**Memorandum:
Fairway Estates Phase II PUD/Subdivision Application**

Date: 09/22/2022
To: City of Florence, Planning Department
From: Metro Planning, Inc.
Subject: Completeness Comments for PC 21 39 SUB 03 & PC 21 40 PUD 02

Subdivision Name: Fairway Estates Phase 2
Map/Lot: 18-12-15-00, TL 1500
Site Address: Florence Oregon 97439

COVER SHEET FOR FAIRVIEW ESTATES PHASE 2 SW 1/4, SECTION 15, TOWNSHIP 18 SOUTH, RANGE 12 WEST, W.M. FLORENCE, LANE COUNTY, OREGON DATE PREPARED: NOVEMBER 5, 2021

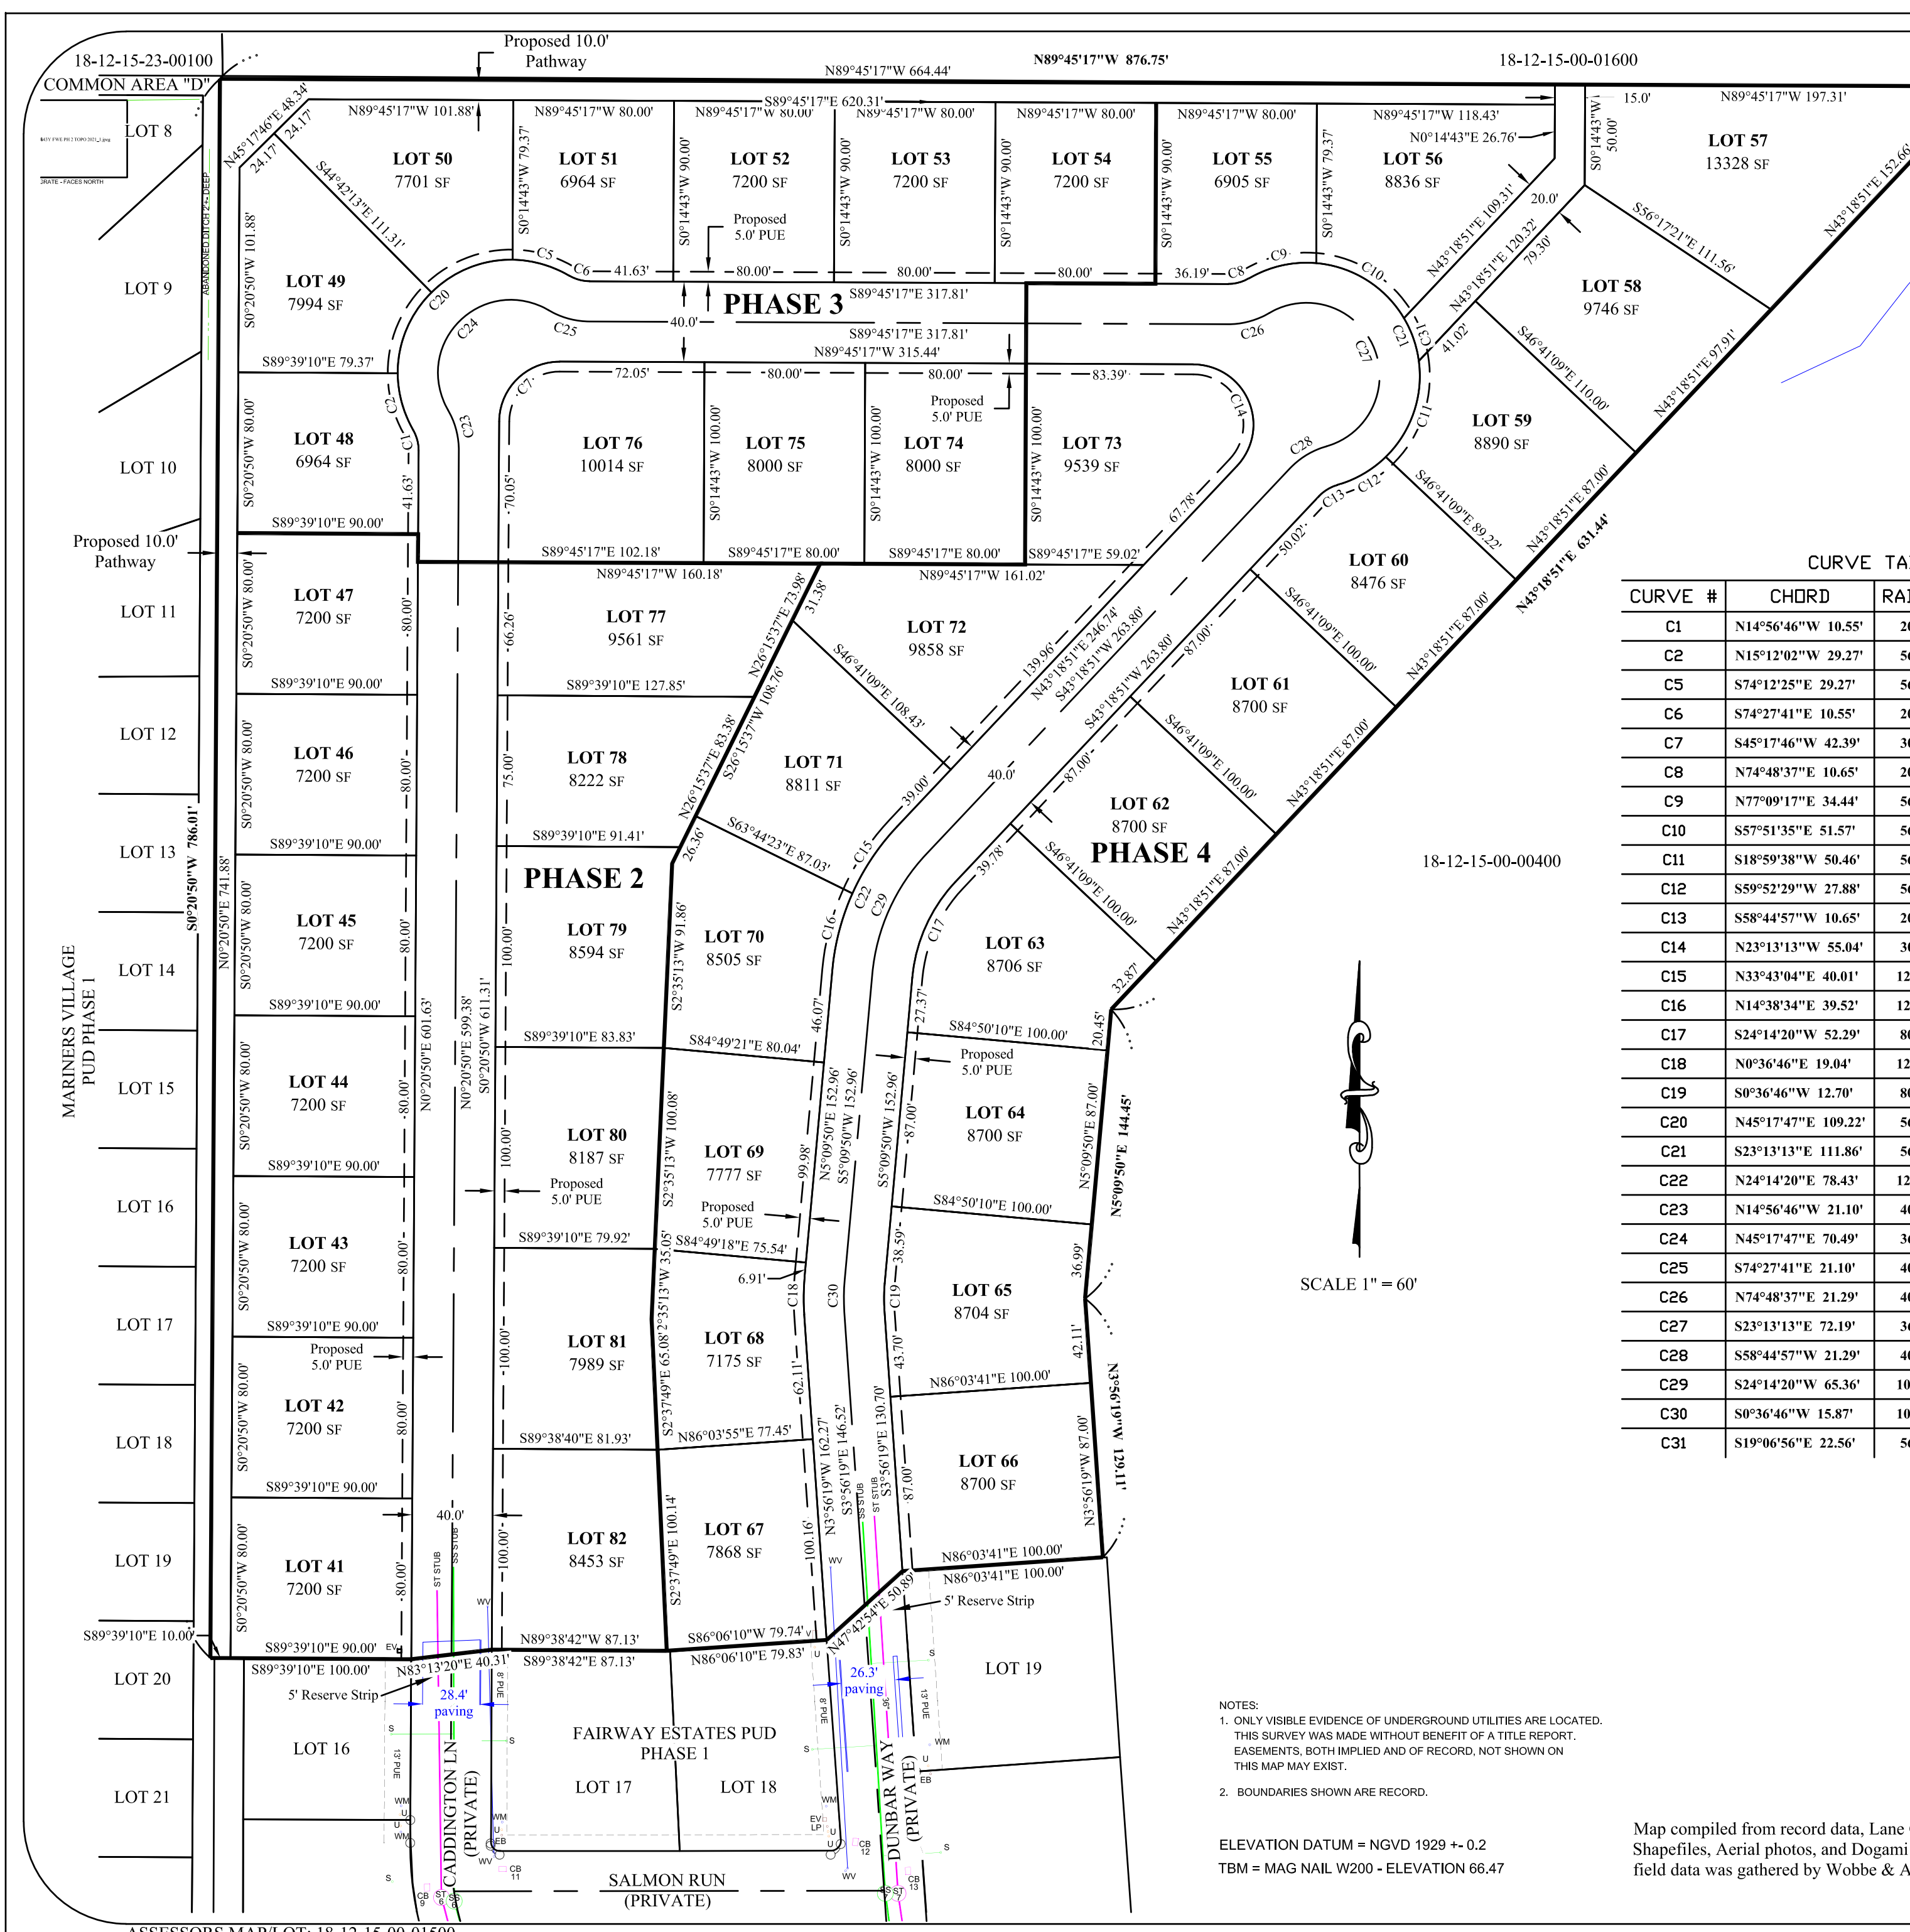
- ***Please consider new street names - Blue Heron Way is a duplicate of a road name used elsewhere in the county. Ironwood is also used elsewhere in the County in other forms and may not be approved by the Lane County Road Naming Committee.***

Response: New street names have been considered and changed in the attached site map⁴ and subdivision referenced below.
